# Duquesne Light

March 17, 1980

Reference: Beaver Valley Power Station, Unit No. 1  
Docket No. 50-334  
LWR Primary Coolant System Pressure Isolation Valves

FIGURE 1 - LOW HEAD SAFETY INJECTION PUMPS TO REACTOR COOLANT SYSTEM COLD LEGS

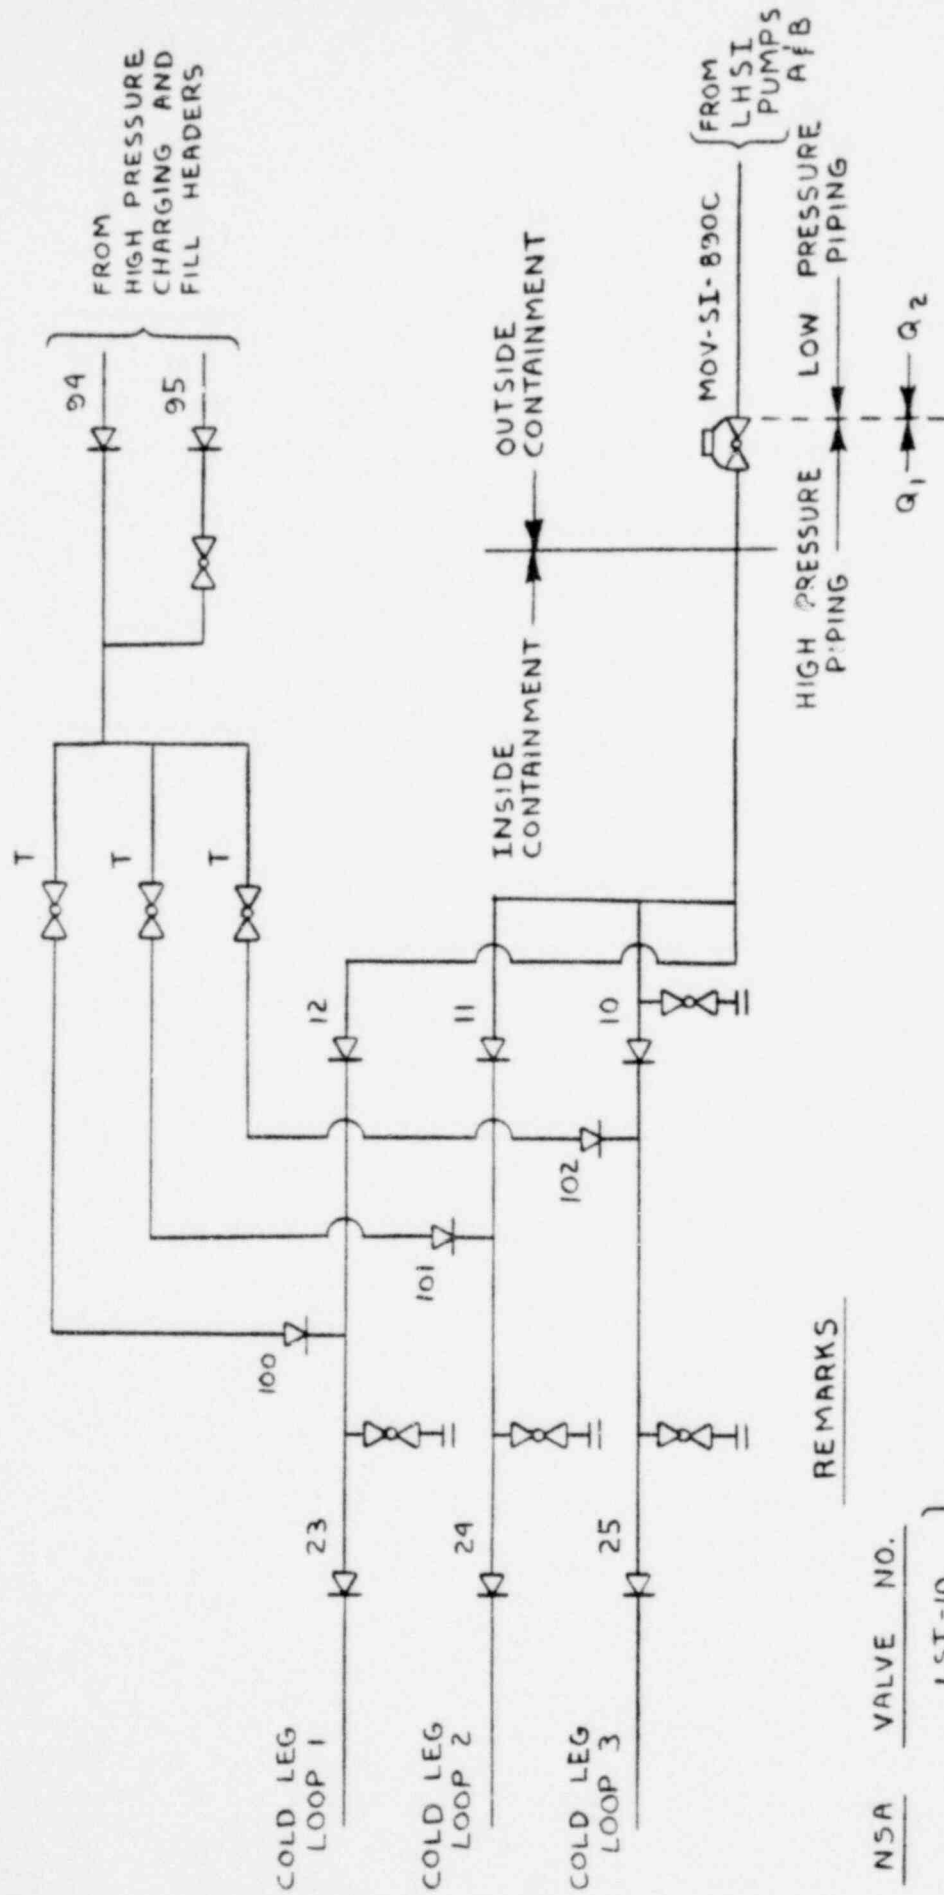
1. We have reviewed all plant systems to determine the existence of an Event V valve configuration of the type described by the two examples in your letter and have concluded that the Safety Injection System is the only system at Beaver Valley Unit No. 1 which fits this description. Figure 1, attached hereto, describes the valve configuration for this system at Beaver Valley Unit No. 1.

2. At the present time, three of the check valves (1SI-10, 11 and 12) and the motor operated valve (MOV-SI-890C) are required to be leak tested at 18 month intervals in accordance with the in-service inspection requirements contained in the ASME Boiler and Pressure Vessel Code, Section XI. The other check valves shown on Figure 1 are not required to be leak tested. None of these valves are continuously monitored for leakage. We have reviewed the maintenance history records for these six check valves and none have a record of, nor are known to have had leakage problems which could lead to an Event V failure.

3. We believe that the leak tightness of the check valves can be improved by observing the upstream pressure after each event which could allow the check valves to open. Therefore, we will install a pressure gauge between the check valves and the discharge of the Low Head Safety Injection Pumps, and we will prepare procedures which will require observation of the pressure gauge for indications of check valve leakage after any operation of the LHSI pumps or if the RCS pressure is reduced below the LHSI pump discharge pressure.
